Champlain Hudson Power Express, Inc.
Case 10-T-0139

Request No.:	Entergy-6	Date of Request:	March 5, 2012
Requested By:	Entergy Nuclear Marketing, LLC	Reply Date:	March 12, 2012
Directed To:	Champlain Hudson Power Express, Inc.		
Subject:	Environmental/Real Property Issues	Witness:	Don Jessome

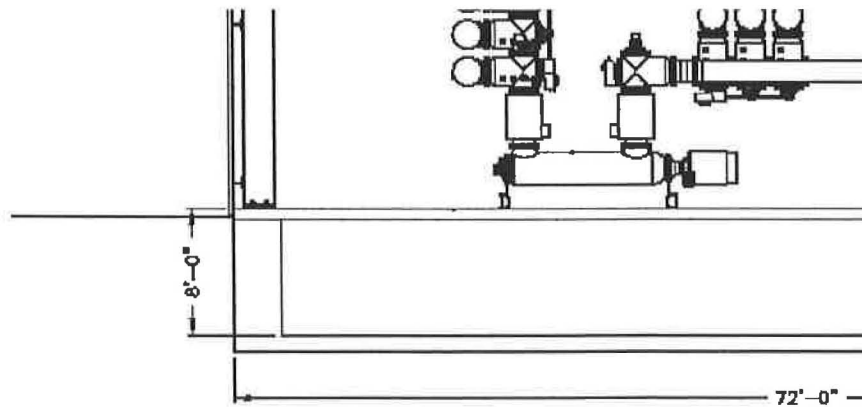
The elevations contained on the line drawing provided by the Applicants to the Settlement Parties as Figure 1 to Exhibit 125 to the JP are illegible. State the depth below "Finished Grade" that is shown on the right-hand portion of Figure 1 to Exhibit 125.

The dimension requested is eight feet (8'-0"). See excerpt below.
